August 24, 2023

Re: Docket No. 508 - The United Illuminating Company Application for a Certificate of Environmental Compatibility and Public Need for the Milvon to West River Railroad Transmission Line 115-kV Rebuild Project - Request for Modification to Structure Locations Near West River Substation

UI 115-kV RR PROJECT MILVON TO WEST RIVER
 DEVELOPMENT & MANAGEMENT PLAN
 SEGMENT 1
 MAPSHEET 3 STRUCTURES AND NOTES

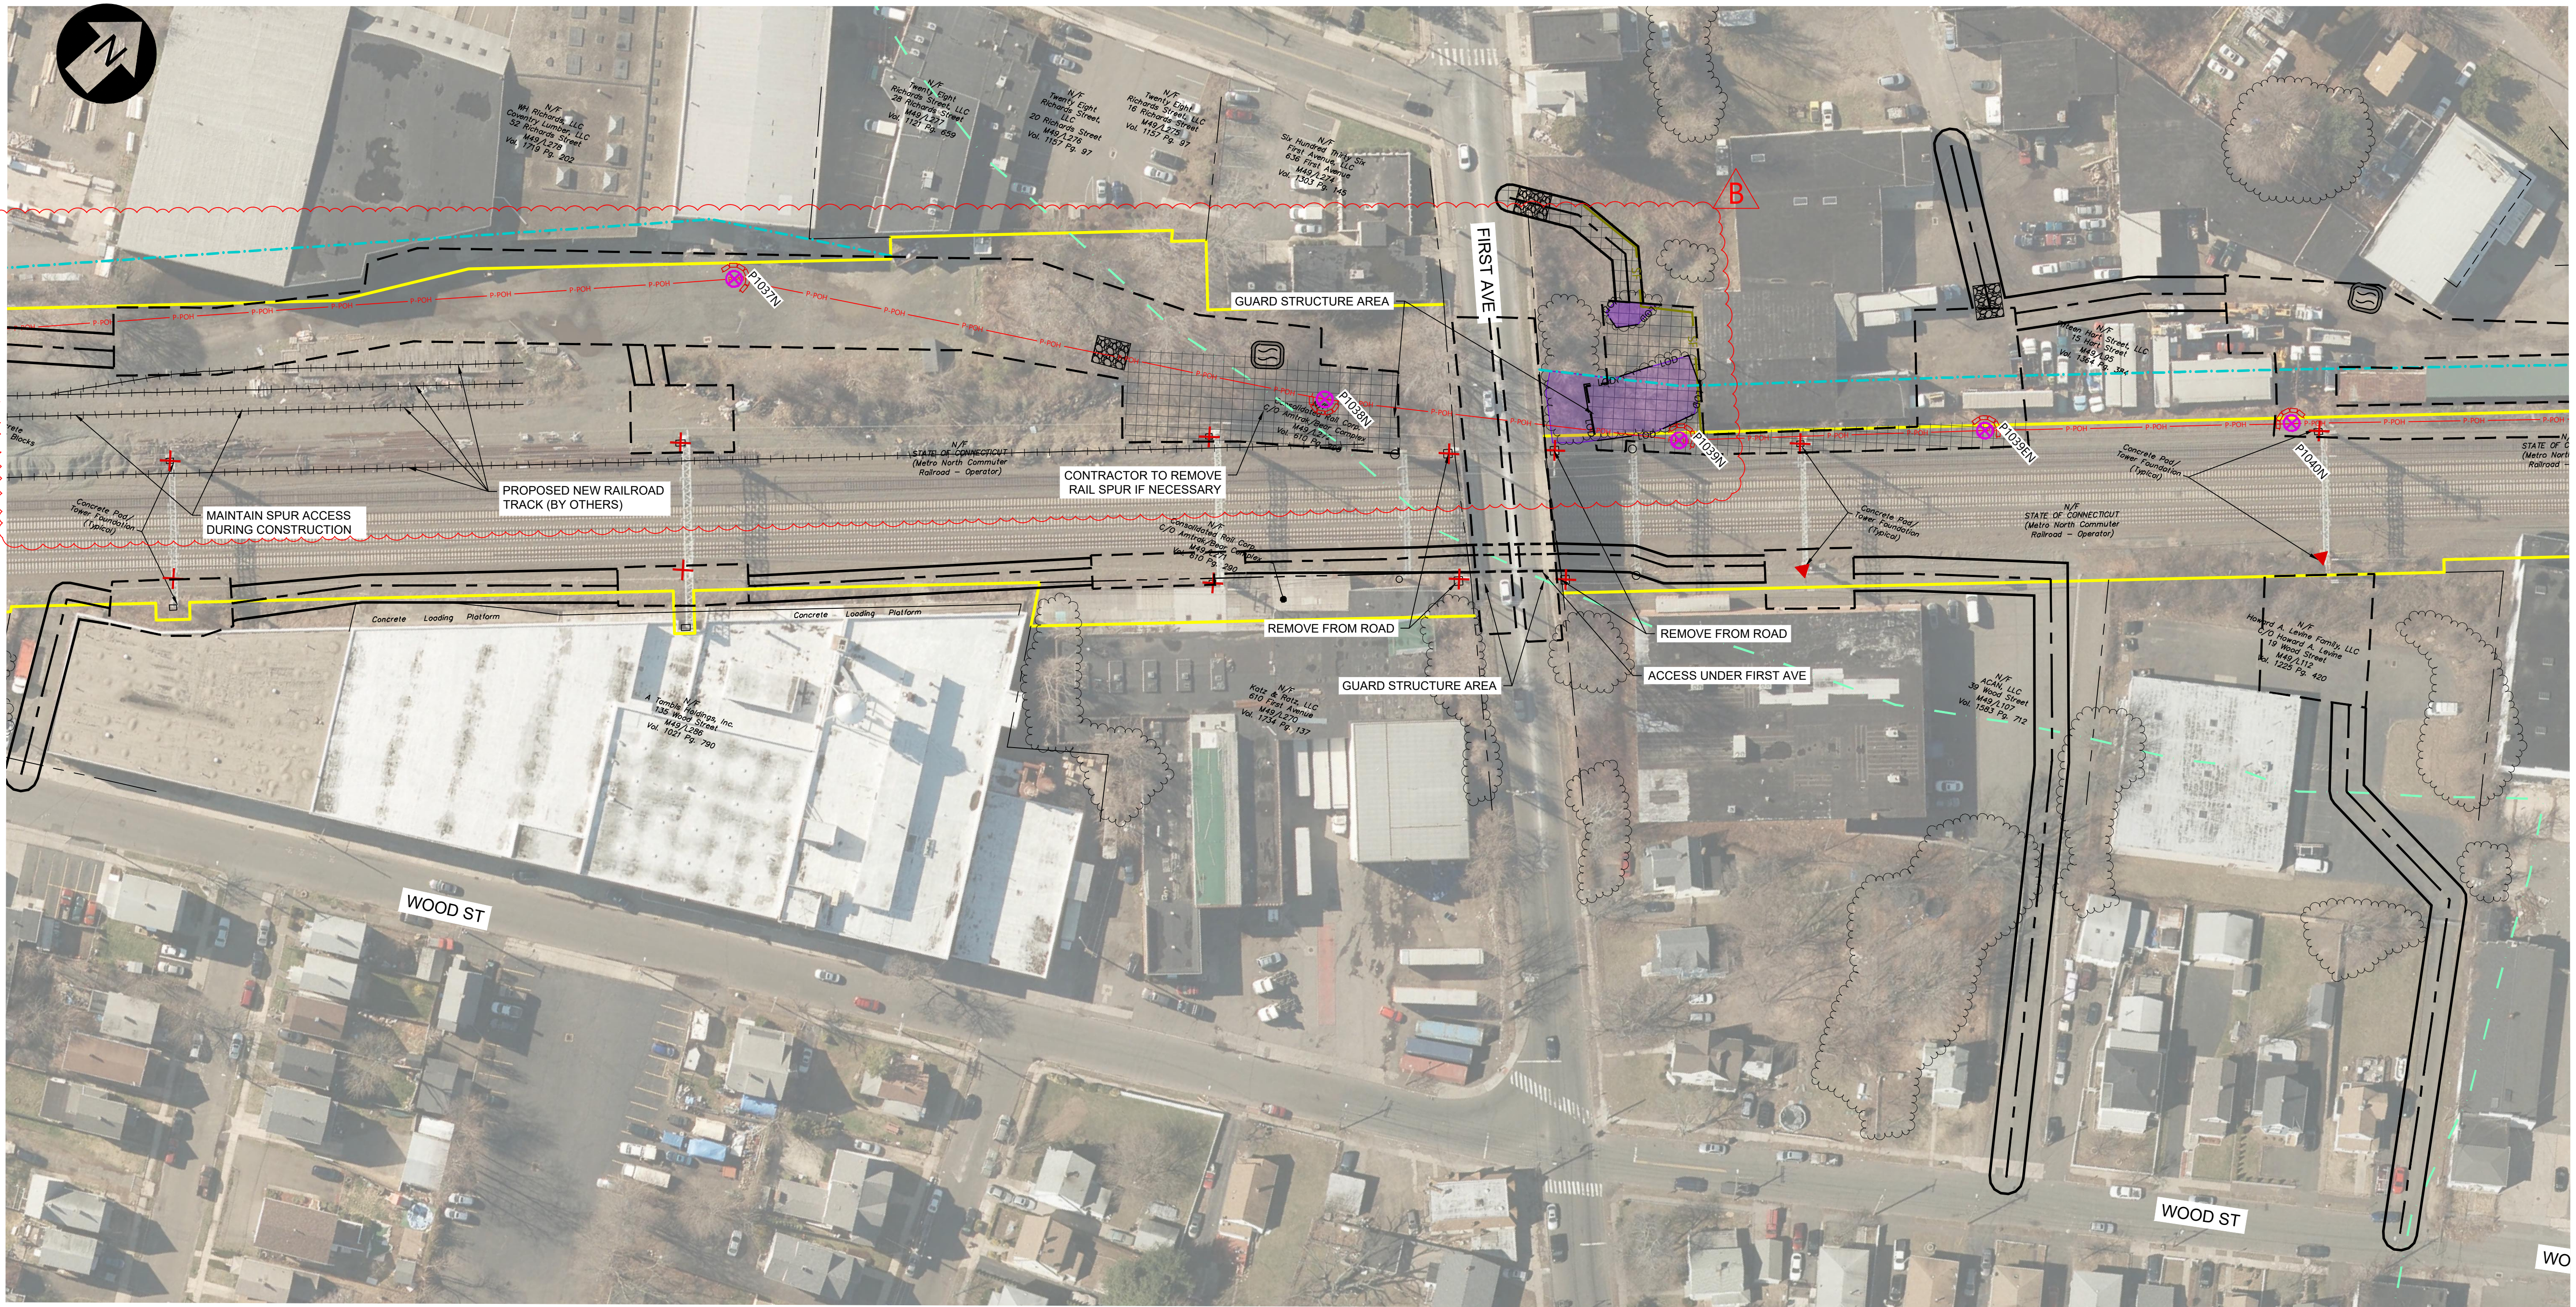
The Company received comments from the Connecticut Department of Transportation ("CDOT") on the positioning of transmission poles on CDOT property within CDOT's West Haven rail yard which is located north of the MetroNorth Railroad ("MNR") tracks (see Segment 1 D&M Plan, Volume 2, map sheets 2 and 3).¹ Based on those comments it was necessary for the Company to modify the location of the planned monopoles as follows:

Structure No.	Pole Length (Original→Revised)	Structure Configuration (Original→Revised)	Transverse Offset* from Original Location (ft)***	Longitudinal Offset** from Original Location (ft)***
P1034N	100'→95'	Tangent w/ Braced Posts→ Deadend w/ Davit Arms	0	0
P1035N	95'→125'	Tangent w/ Braced Posts→ Tangent w/ Braced Posts	20	52
P1036N		Removed		
P1037N	95'→120'	Deadend w/ Davit Arms →Deadend w/ Davit Arms	47	33
P1038N	125'→125'	Tangent w/ Braced Posts→ Tangent w/ Braced Posts	0	35

- One of the double circuit steel monopoles originally planned for location along the north side of the MNR tracks in West Haven will be eliminated.
- Structures P1035N and P1037N will increase in height (to 120 and 125 feet, respectively) because of increased span length due to the elimination of P1036N and to maintain required vertical clearances for an adjacent building. These two structures were shifted farther north to accommodate the future planned spur tracks and work areas for MNR and CDOT.
- The realignment of P1035N and P1037N to the northern edge of the CDOT property will require easements on adjacent private properties, which will result in an additional 0.34 acre of permanent easements for the Project.
